DRG. NO.	MODEL	MATERIAL	FINISH	TITLE	DWG. NO.	PARTS NO.	APPROVED.	DRAWN	DATE	Q'TY	SCALE	UNIT
D-06				L型固定片	B7281831	B7281831			12/25/06		1=1	mm.
D-30				AREMO-4185								
30-60				SPCC.3.0T.								
30-180				Pantone 877C.								
30-315												
310-800

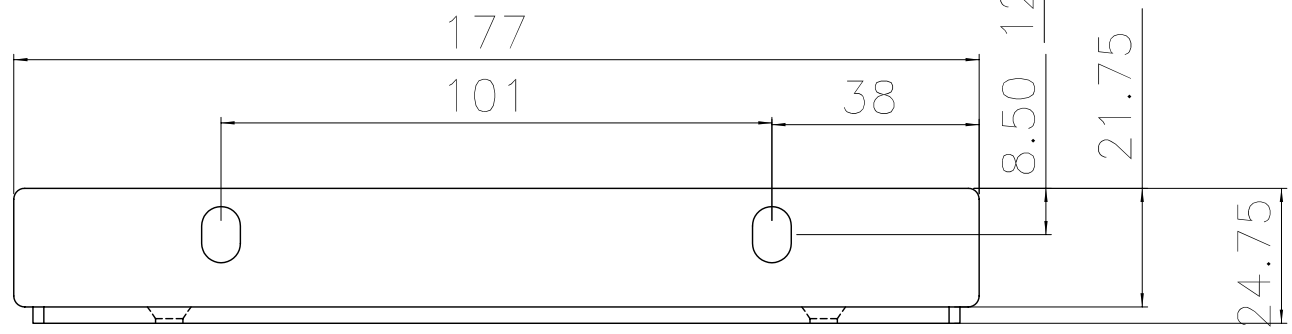
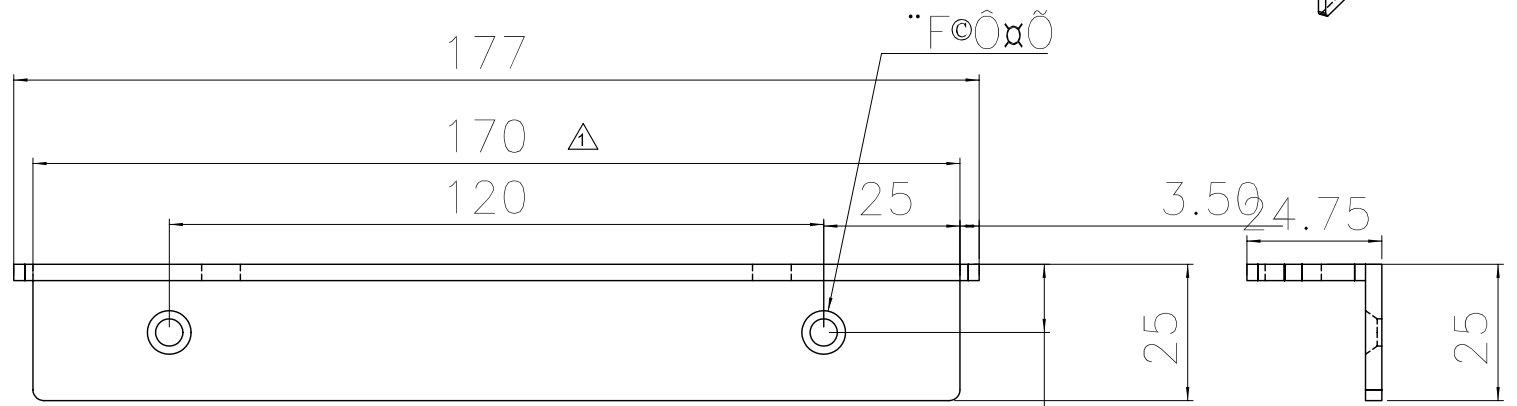
圖面與實際零件尺寸不同，依照模具品修改尺寸
